UNITED STATES
NUCLEAR REGULATORY COMMISSION
WASHINGTON, D.C. 20555-0001

SUBJECT: PERRY NUCLEAR POWER PLANT, UNIT 1– FLOOD HAZARD MITIGATION STRATEGIES ASSESSMENT (CAC NO. MF7960; EPID L-2016-JLD-0007)

STAFF ASSESSMENT RELATED TO THE
MITIGATION STRATEGIES ASSESSMENT FOR
PERRY NUCLEAR POWER PLANT, UNIT 1
AS A RESULT OF THE REEVALUATED FLOODING HAZARDS REPORT
NEAR-TERM TASK FORCE RECOMMENDATION 2.1- FLOODING
(CAC NO. MF7960; EPID L-2016-JLD-0007)

Figure 3.6.1 Perry Nuclear Power Plant with proposed layout of site modifications. (Source: FENOC Audit –Licensee generated figure, See Section 4) (Source: Public Meeting held June 29, 2017 (ADAMS Accession No ML17193A419))

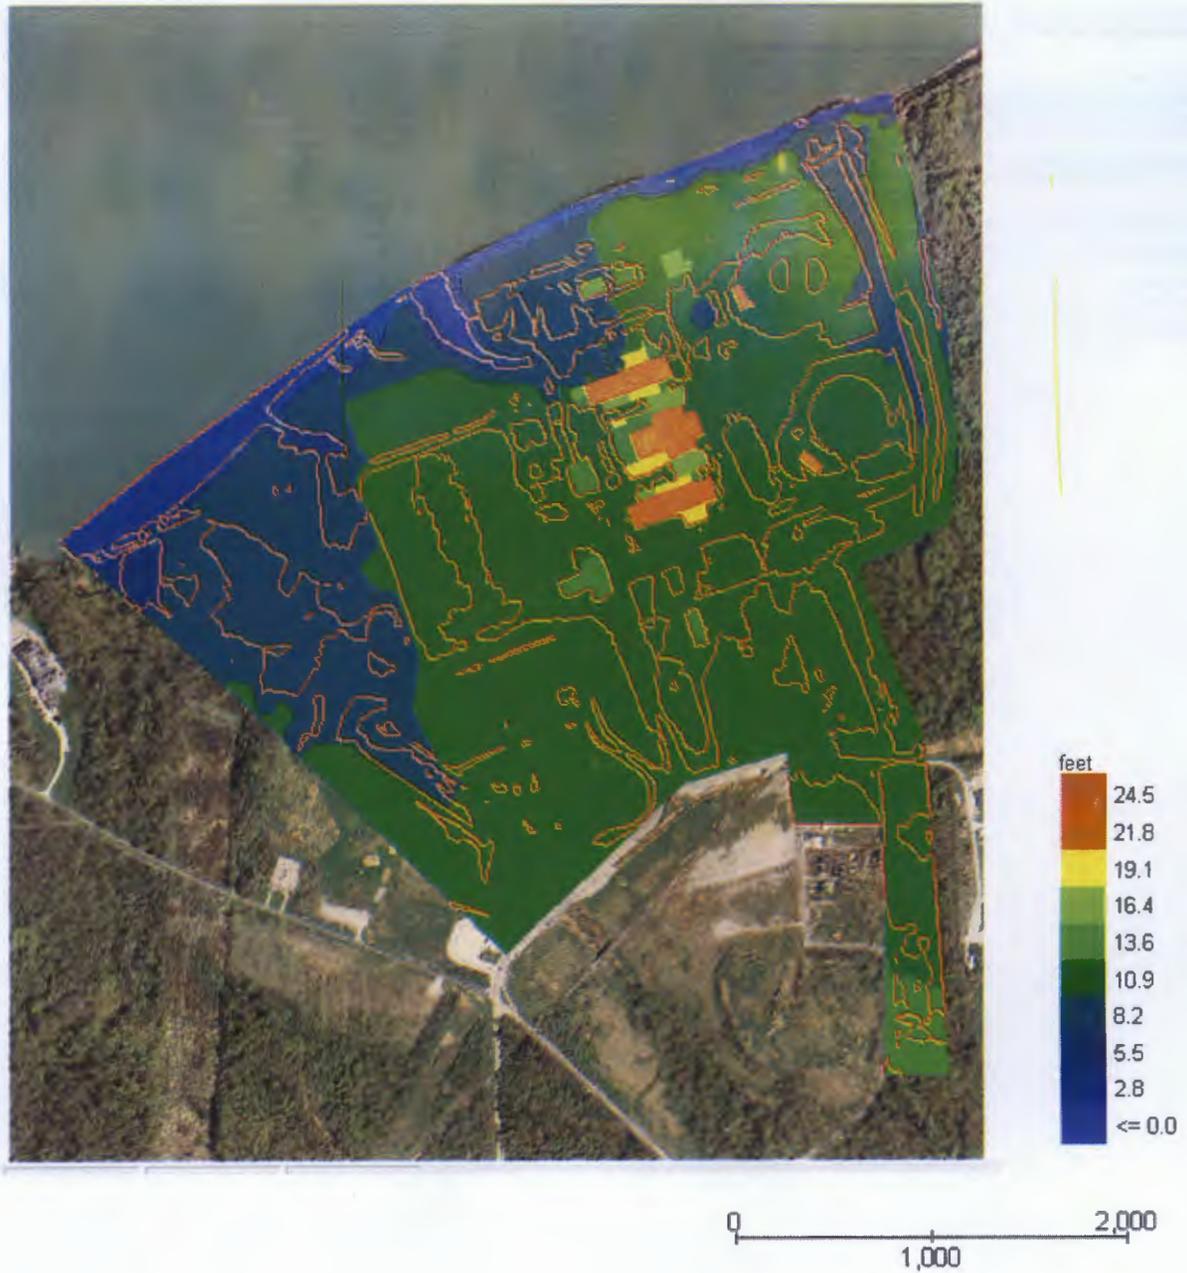
As stated in the MSA, FENOC is in the process of reconstituting the flooding design basis at Perry, which includes the LIP event. The licensee is crediting modifications, taken or planned at the site, in order to conclude that the reevaluated hazards have no impact on the FLEX strategies. The design basis reconstitution is expected to utilize a time-based warning protection scheme in which incorporated barriers and specific trigger points will be required. Specifically, some of the actions being tracked in the corrective action program (CAP) and planned for implementation at Perry include, but are not limited to:

- For doors required for FLEX activities, installing flood protection barriers with the intended function of preventing flood waters to enter the buildings,

- Establishing and implementing a warning time and trigger point for the installation of flood barriers,
- Developing a proceduralized plan and pre-stage materials for flood barriers that are to be installed on Powerblock doors and openings,
- Completing Powerblock building flood protections and/or modifications, as necessary,
- Implementing flood protection features for the diesel generator fuel tank flame arrestors,
- Developing preventive maintenance documents for the Diversion Stream berm inspection, stream debris clearing and maintenance of ground cover overgrowth, and inspection of the site storm sewer system.

Because FENOC is in the process of reconstituting the flooding design-basis at the site and the implementation of the proposed modifications is ongoing, the NRC staff was not able to review the specific details for this assessment. However, based on the licensee's description of the planned activities, the staff concludes that, if implemented as described, the strategies appear reasonable and should allow FLEX strategies to be implemented.

Figure 3.6.2 Perry Nuclear Power Plant with proposed layout of site modifications simulated by FLO-2D, including maximum WSEs (feet NGVD29 minus 600 feet) in color map with major Inundation Area in red line. (Source: NRC Staff independent confirmatory analysis using FLO-2D).

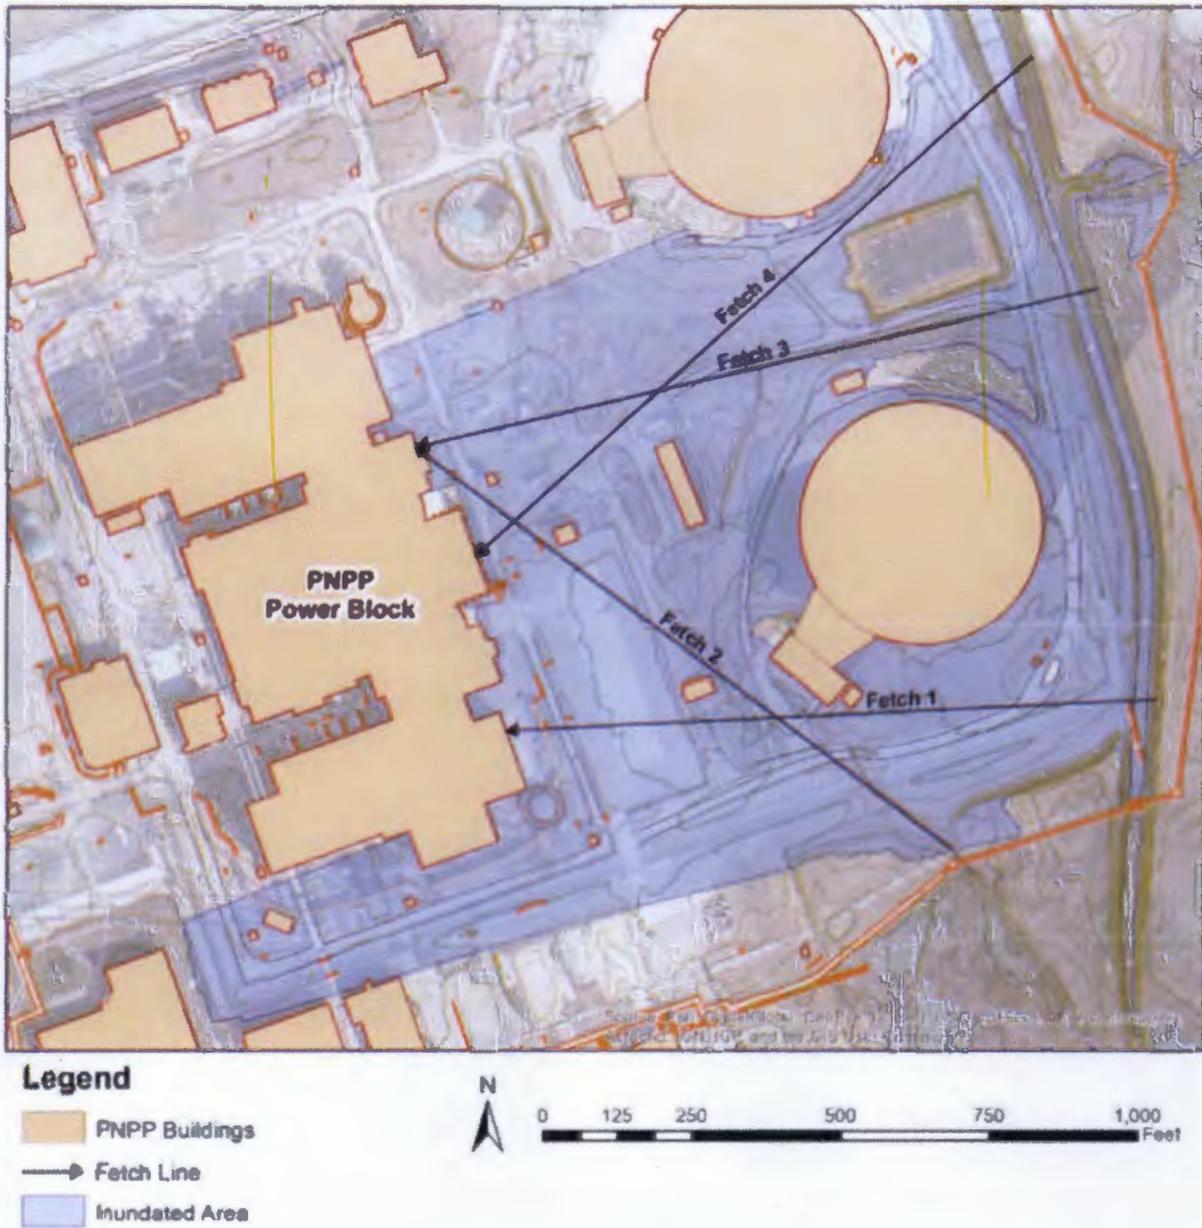
The licensee stated that for the LIP flood causing mechanism, the WSE inundates the Powerblock area and poses challenges for FLEX as a result of flooding of the deployment paths, staging areas, and water levels above critical doors which are important for implementing the FLEX strategies. However, the installation of door flood barriers and alternative deployment paths available will make it possible for the implementation of the FLEX strategies. The licensee used FLO-2D Pro software (FLO-2D, 2013: Build 16.06.16 which incorporates the Storm Water Management Model [SWMM] 5.0.022) to determine the maximum WSEs and flood depths for the LIP event at critical door locations. Figure 3.6.2 presents the FLO-2D confirmatory analysis LIP flooding maximum WSE and inundation area, while Figure 3.6.3 presents the inundation area details resulting from the Minor Stream and LIP with fetch lengths. The licensee stated in its MSA that the fetch lengths are insignificant to the result in wave runup. The NRC staff performed a confirmatory modeling of the LIP flooding mechanism using data obtained from the licensee as part of the audit, the FLO-2D modeling software, and present day guidance and methodologies. The confirmatory modeling was performed to verify the licensee's modeling parameters and consistency of the reported WSEs. Based on its review of information provided by the licensee, the NRC staff confirmed that the results of staff's confirmatory modeling for WSEs are consistent with the values stated in the MSA report, and the supporting information reviewed as part of the audit. Therefore, the NRC staff determined that the reported changes in the simulated LIP flood elevation values (summarized in Table 3.6-1) are inconsequential, and that the updated flood levels provided in the MSA are acceptable for use in the evaluation of FLEX strategies.

The NRC staff confirmed that the licensee's reevaluation of the inundation periods for LIP and associated drainage uses present-day methodologies and regulatory guidance. As previously stated, although the licensee did not provide a validated warning time in its MSA, the NRC staff notes that the licensee could use the guidelines provided by NEI 15-05 (ADAMS Accession No. ML15104A158) in order to determine a more realistic LIP warning time (as needed) for its focused evaluation.
